HISTORIC DISTRICT COMMISSION NOTICE OF DENIAL

Application Number: HDC2025-00596

APPLICANT & PROPERTY INFORMATION			
NAME: Timothy Flintoff Jr.	COMPANY NAME: 4545 Architecture		
ADDRESS: 2761 E. Jefferson Ave, Ste 302	CITY: Detroit	STATE: MI	ZIP: 48207
PROJECT ADDRESS: 4314 W. Vernor Hwy			
HISTORIC DISTRICT: Hubbard Farms			
SCOPE: <ul style="list-style-type: none">Remove brick veneer at façadeInstall new brick claddingReplace storefront at existing openingRemove wood boards above storefront			
<p>At the Regular Meeting that was held on 11/12/25, the Detroit Historic District Commission (“DHDC”) reviewed the above-referenced application. Pursuant to Section 5(1) and 9(1) of the Michigan Local Historic District Act, as amended, being MCL 399.205 (1), MCL 399.209 (9) and Sections 21-2-78 and 21-2-80 of the 2019 Detroit City Code; the DHDC hereby issues a Denial for the following work, effective on 11/18/25, as it will be inappropriate according to the Secretary of Interior’s Standards for Rehabilitation and the district’s Elements of Design:</p>

HISTORIC DISTRICT COMMISSION ADDITIONAL INFORMATION REQUEST

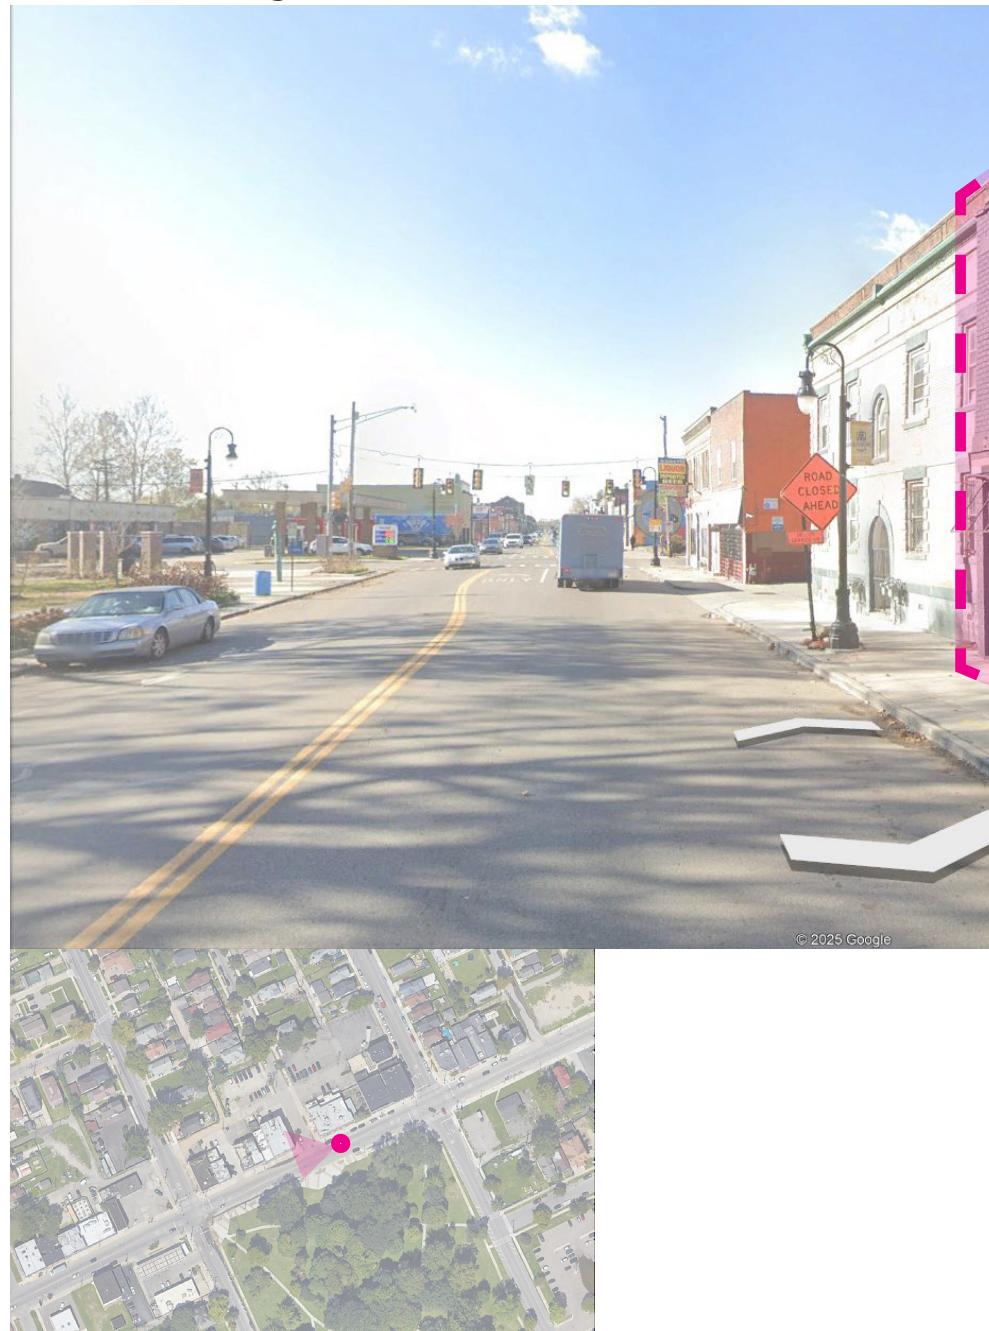
This application is not complete. Please provide the following:

- Detailed dimensioned drawing of proposed storefront system with material(s)
- Note: although the concept drawing is appreciated, we need a detailed drawing of what is proposed, including what materials are to be used the the WHOLE storefront system, including the doors
- Window schedule, which includes...
- New windows design, operation, lite configuration, and dimensions
- Product information identifying the exact proposed replacement brick and colorway(s), including dimension of the brick
- Dimension of the existing historic brick (not the storefront infill brick)

- Narrative explaining why the decision was made to replace the whole brick facade

see attached revised submission

New Facade

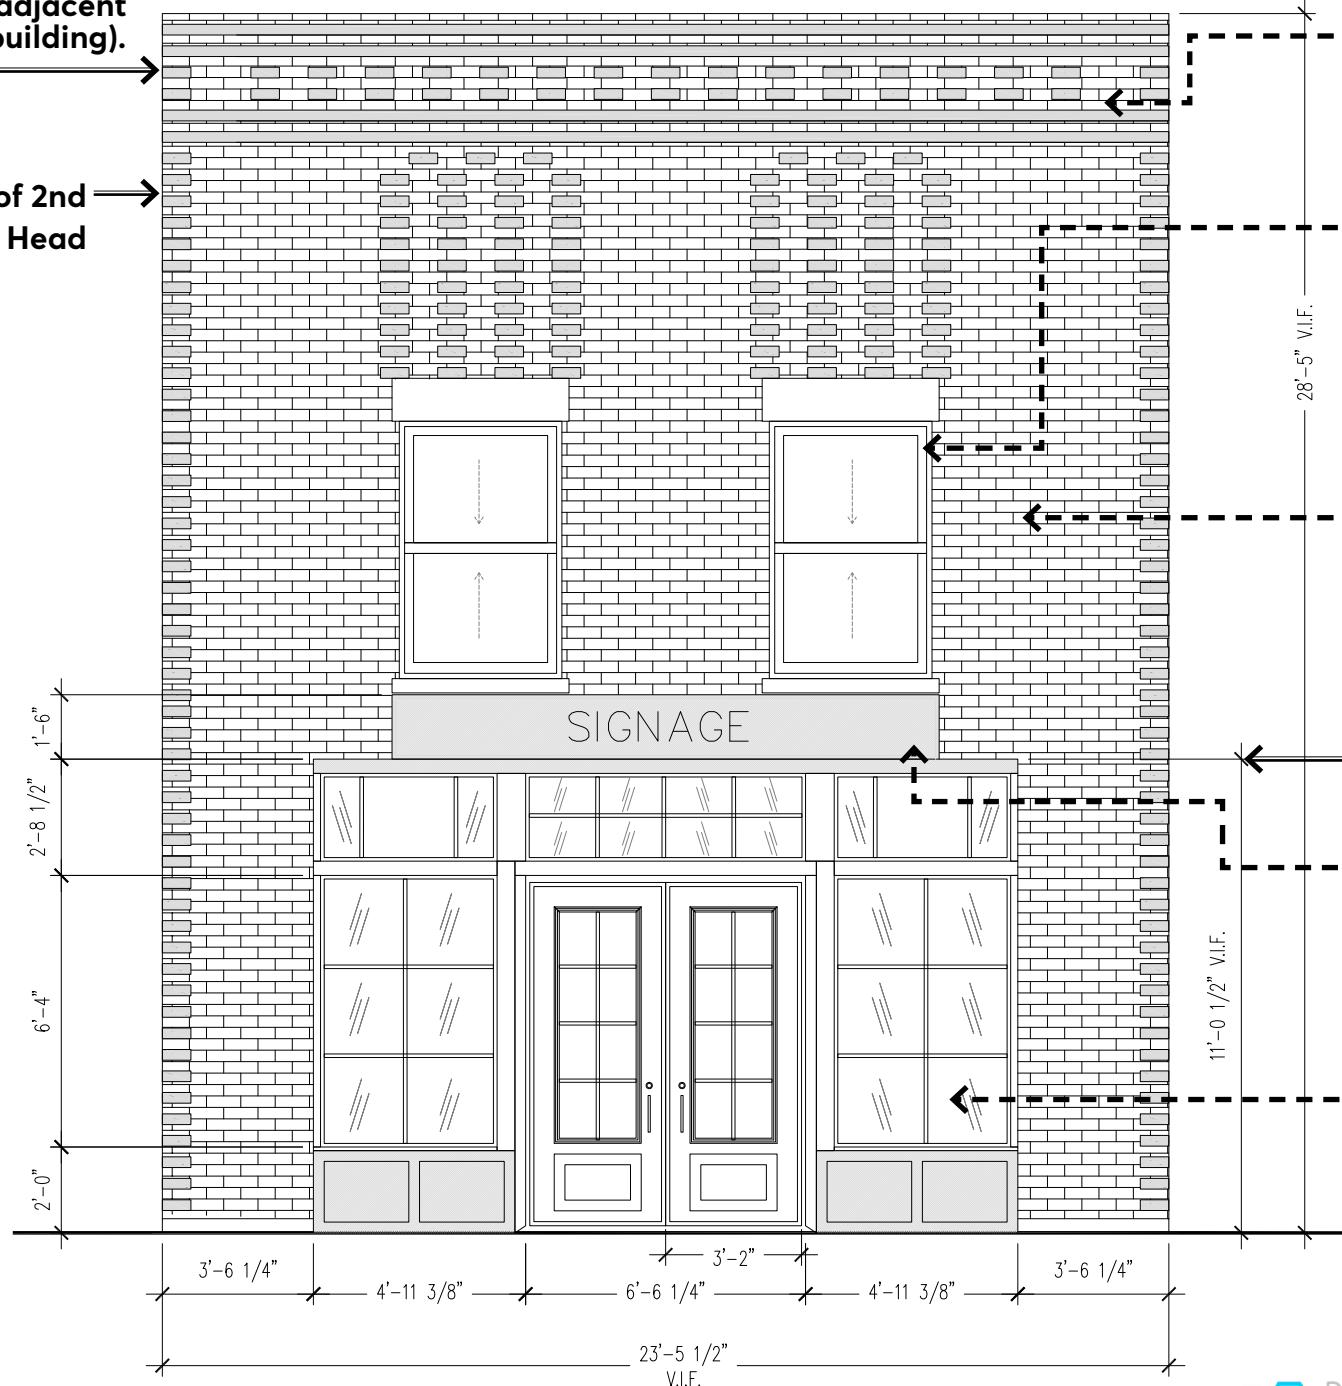
REASONS FOR DENIAL:			
<ul style="list-style-type: none">The historic brick veneer at the façade is a distinctive, character-defining feature and not proven to be beyond repair.Introducing features that are not based on documented historical evidence, including architectural elements copied from other buildings and styles, creates a false sense of history.

Failure to meet standards: 2, 3, 5, 9

Failure to meet Elements of Design: 7, 19
